Project	<b>IEEE 802.16 Broadband Wireless Access Working Group</b> < <a href="http://ieee802.org/16">http://ieee802.org/16</a> >	
Title	<b>Congestion control mechanism for interworking between WLAN and WMAN</b>	
Date Submitted	<b>2003-12-27</b>	
Source(s)	<p>Marc Engels Peter Coenen IMEC Kapeldreef 75 B-3001 Leuven Belgium</p> <p>Bernhard Walke Christian Hoymann Communication Networks Aachen University Kopernikus Str. 16 D-52074 Aachen Germany</p>	<p>Voice: +32 16 28 16 17 Fax: +32 16 28 86 50 <a href="mailto:marc.engels@imec.be">marc.engels@imec.be</a> <a href="mailto:peter.coenen@imec.be">peter.coenen@imec.be</a></p> <p>Voice: +49 241 80 27954 <a href="mailto:hoy@comnets.rwth-aachen.de">hoy@comnets.rwth-aachen.de</a></p>
Re:	Call for contribution IEEE 802.16d-03/83	
Abstract	This contribution proposes an enhancement to the service flow change mechanism	
Purpose	For inclusion in the 802.16-REVd_D2 amendment document

## Congestion Control

Figure 21—MAC SAP event and MAC event sequence for temporary traffic reduction stimulated by CS

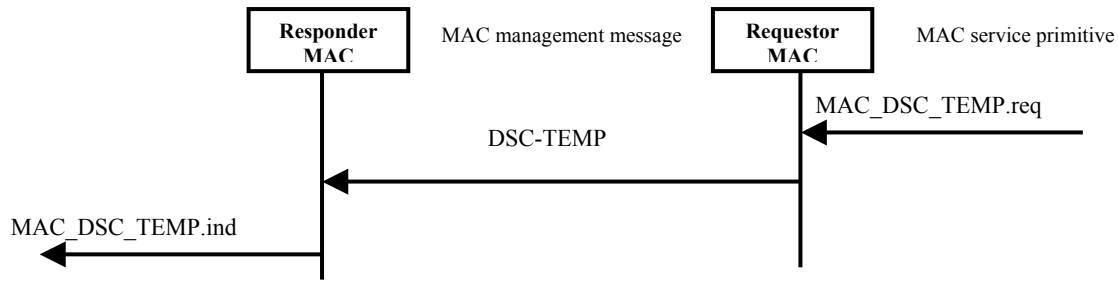
##### ***Add new text line 27 p.44***

The sequence of logical MAC SAP events and the associated actual MAC events effecting a CS stimulated temporary traffic reduction are shown in Figure 21.

Figure 125 - DSC-TEMP mechanism

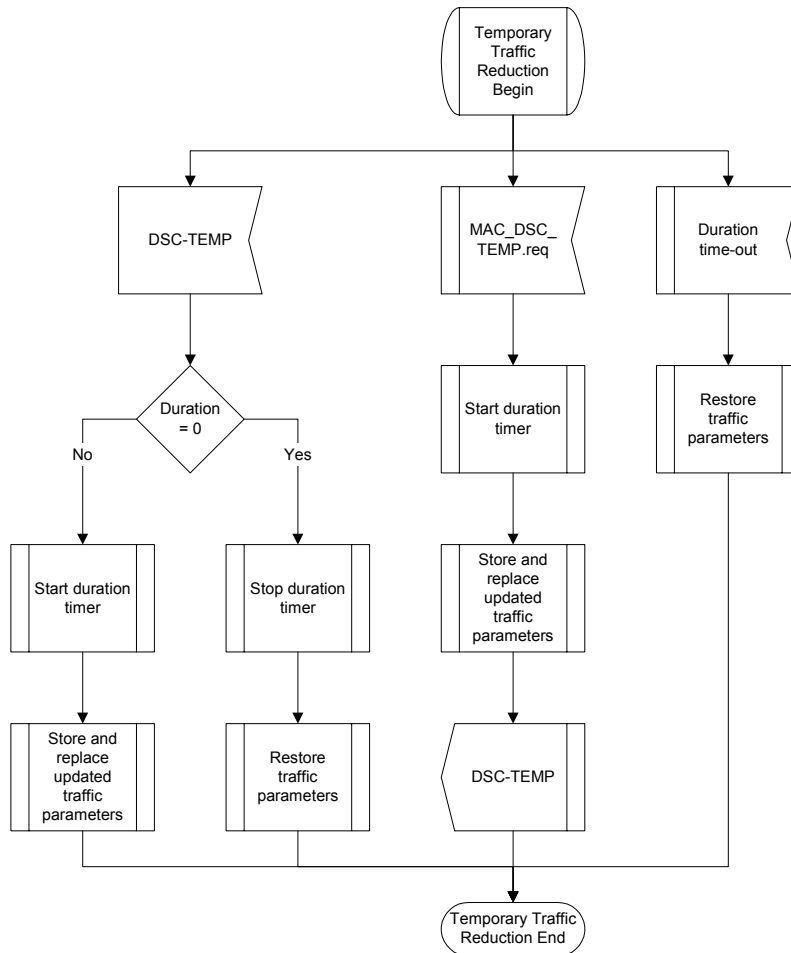
*Add on page 250 line 31 the chapter below :*

**6.4.13.10.6 Temporary traffic reduction**

The temporary traffic reduction mechanism is a fast, low overhead mechanism, which realizes a temporary traffic reduction for the concerned transport connection.

Figure 125 shows the State Transition diagram for this mechanism.
